Determination 2009/83

The code compliance of proposed barriers for the walkways at a stock yard at 114 Waharoa Road, East Matamata

Figure 3: Cross section of a race showing the gates and walkways
(note the configuration of the balusters varies from the sketch with respect to the width of the balusters as sketched – refer figure 1)

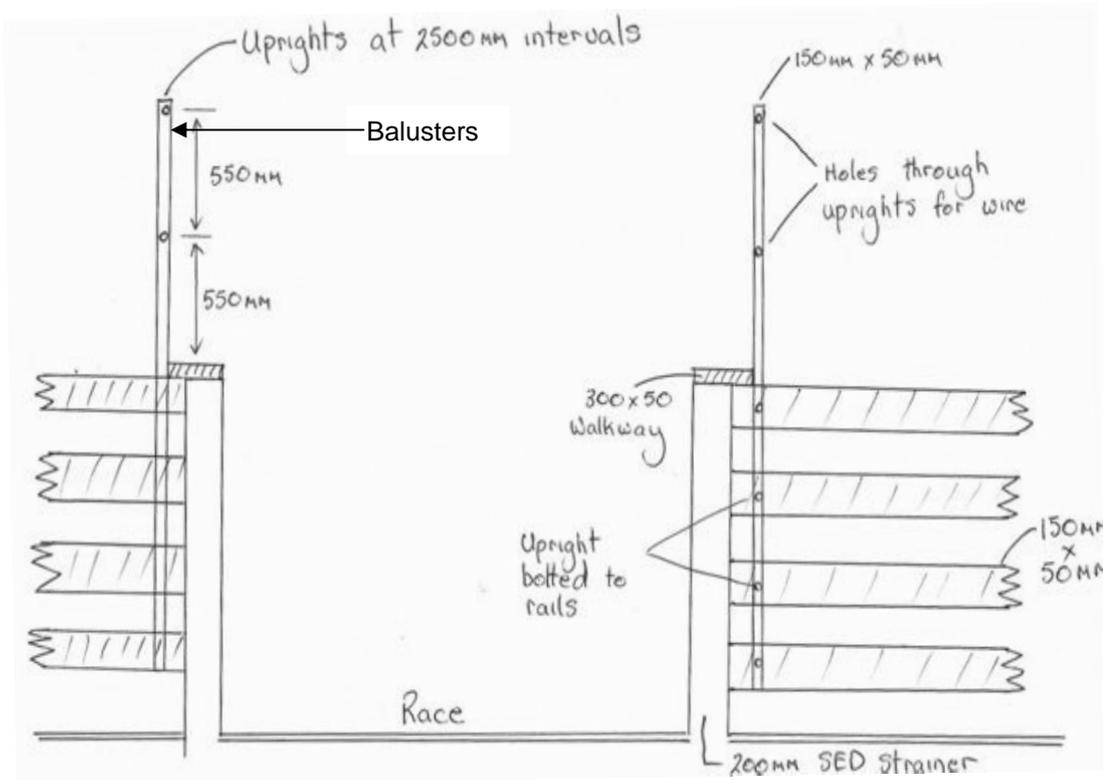
- 2.5 The timber balusters are 150×50mm at 2.5 metre centres. The barriers to the walkways are proposed to be constructed of tightly drawn plastic covered 5mm rope wire, which is proposed to be held up by the already constructed timber balusters. The barriers would each have two wires, one at mid-height, and the other at the top of the baluster post. Figure 3 shows the cross section, showing the race walkway, and the proposed balustrade detail

- 8.1 The wire barriers are proposed to be on both sides of the pen walkways, but on only one side of the race walkways. The authority contends that by having barriers only on one side of the race walkways, the walkways do not meet the requirements for Clause F4 of the Building Code.

- 8.2 Clause F4.3.1 shall not apply where 'such a barrier would be incompatible with the intended use of an area'. I consider that these 'limits on application' apply to the race walkways because providing barriers to both sides of these walkways would be incompatible with the intended use of the area, in that they would prevent the staff from effectively carrying out their duties in a safe manner. The race walkways are considered service areas, and are only intended for use by staff, for the purposes of carrying out their duties. Furthermore, as staff must be in the races to control the flow of the stock, barriers to both sides of the race walkways would prevent staff from being able to climb out of the races onto the walkways if stock becomes aggressive.

- (e) be constructed to prevent people falling through them.
- 9.4 I accept that the wire barriers will be continuous, be of appropriate height, and will provide a grabable wire for people falling away from the wire and a physical barrier for people falling into the wires.

- 10.1 As discussed in 9.5, I consider that the adequate rigidity and adequate strength provisions of Clause F4 are required to be met. I am of the view that it is useful to compare the proposal for wire barriers to the walkways with the Acceptable Solution for Clause B1, although I note the Acceptable Solution relates to timber barriers with rigid top and bottom rails.
- 10.2 The baluster spacing for the wire barriers is greater than the maximum baluster spacing in the Acceptable Solution. Furthermore, it appears that the baluster posts

will provide less rigidity in the direction along the line of the barrier than the baluster posts for the maximum baluster spacing for the Acceptable Solution.

10.3 The net effect of these suggests that it may not comply with the structural requirements. I also note that apart from the timber balusters, there is no other rigidity in the proposed system. Based on this information, I conclude that the proposal does not have sufficient strength and rigidity.

10.4 I am of the view that a detailed analysis of the strength and rigidity of the barrier system is required to be undertaken, if it is to be demonstrated that the wire barriers comply with the strength and rigidity requirements of Clause F4.3.4 (c) and (d).

11.2 The proposal should be considered as a proposed alternative solution, and therefore the applications will need to include an assessment of the strength and rigidity of the wire barriers and details of the management plan.

- the proposal to have barriers to only one side only of the race walkways complies with Clause F4
- the proposal to have wire barriers to the race and pen walkways complies Clause F4, other than the requirements for strength and rigidity of Clause F4.3.4(b) and (c).
- the proposal to have wire barriers to the race and pen walkways does not comply with Clause B1.
